DEVELOPMENT ASSESSMENT PANEL REPORT	
Application No.	DA/2023/1123
Address	37 John Street LEICHHARDT
Proposal	Demolition of existing building and construction of a new two storey light industrial development to John Street and a new warehouse with mezzanine office over basement parking to Whites Creek Lane with associated site works
Date of Lodgement	29 December 2023
Applicant	JDS DP C/- Koturic & Co.
Owner	KRDJ Pty Ltd
Number of Submissions	Fifteen (15) submissions received, eleven (11) of which are unique
Cost of works	\$1,889,070.00
Reason for determination at Planning Panel	Number of submissions received FSR variation exceeds 10%
Main Issues	Flooding and stormwater management, and design implications to address flooding and stormwater management issues. Proposed parking to the warehouse and industrial units are below the flood planning levels for both John Street and Whites Creek Lane. Unencumbered evacuation of the warehouse from Whites Creek Lane to John Street is not provided.

Recommendation	Refusal
Attachment A	Reasons for Refusal
Attachment B	Plans of proposed development
Attachment C	Recommended conditions of consent if approved
Attachment D	Stormwater Plans (Issue F)
Att

Figure 2. Flood Certificate (provided by Council)

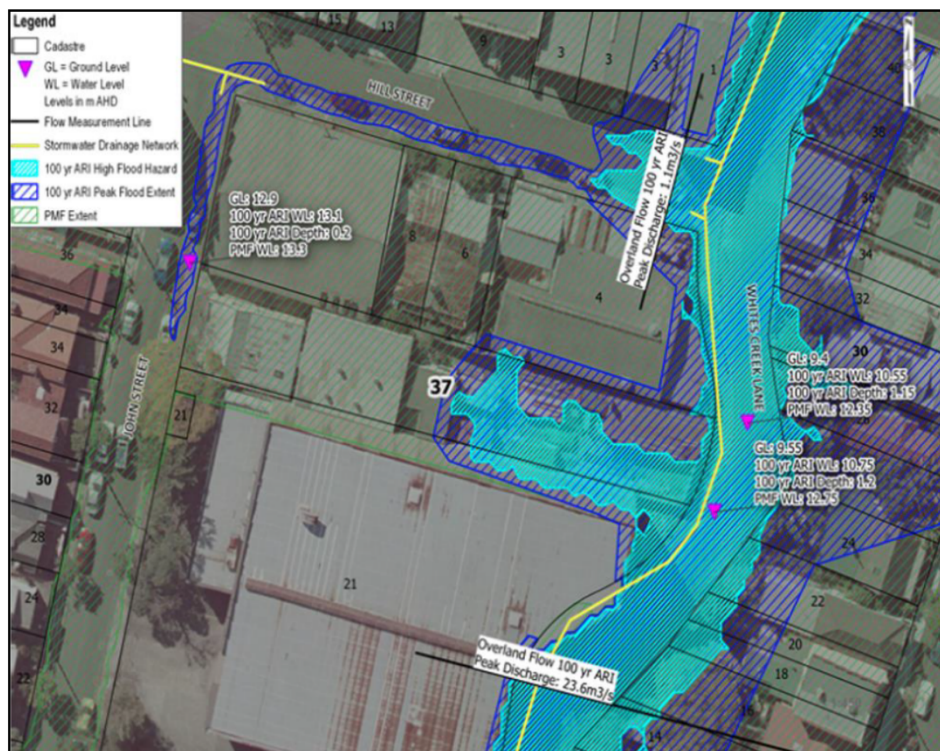
- c. The floor levels at the John Street frontage have not been set at the flood planning level for John Street as required by Control C4 (E1.3.1). The Flood Certificate indicates that the 1 in 100 year flood level in John Street adjacent to the site is 13.1m AHD which is 110mm above the driveway/footpath level and therefore overland flows will enter the property from John Street and flood the garage and industrial units which are below the footpath level. A side setback is required to address these overland flows and prevent inundation of the Industrial units in accordance with Control C2 (E1.2.2);

Figure 4. Impact of Proposed Development (1% AEP Flood Level Difference)

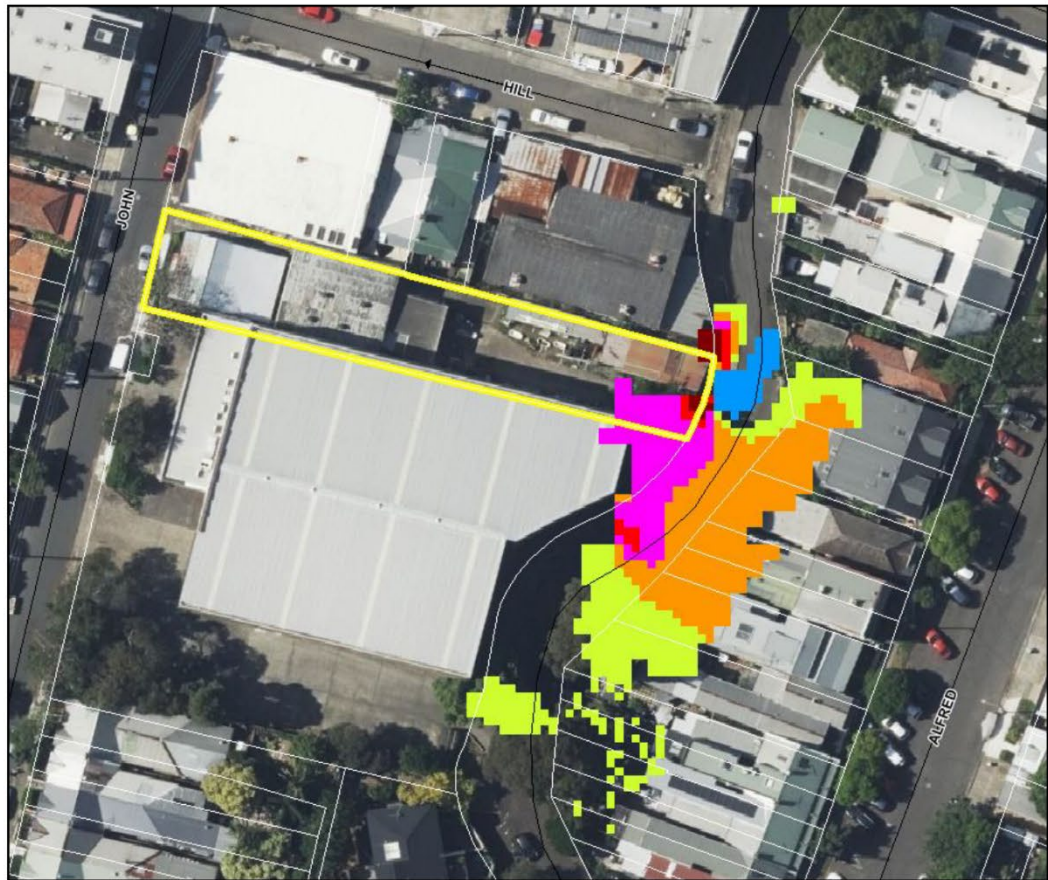
The Flood Risk Management Study found that the proposed development would have adverse impacts of up to 30mm on properties to the east side of Whites Creek Lane. This was difficult to assess as Figure 4 did not have a legend. However best practice is to reduce impacts to no more than 10mm so as to avoid adverse impacts due to cumulative impacts of development.

- b. The Flood Risk Management Study found that the proposed development would have adverse impacts of up to 30mm on properties to the east side of Whites Creek Lane. This was difficult to assess as Figure 4 did not have a legend. However best practice is to reduce impacts to no more than 10mm so as to avoid adverse impacts due to cumulative impacts of development.
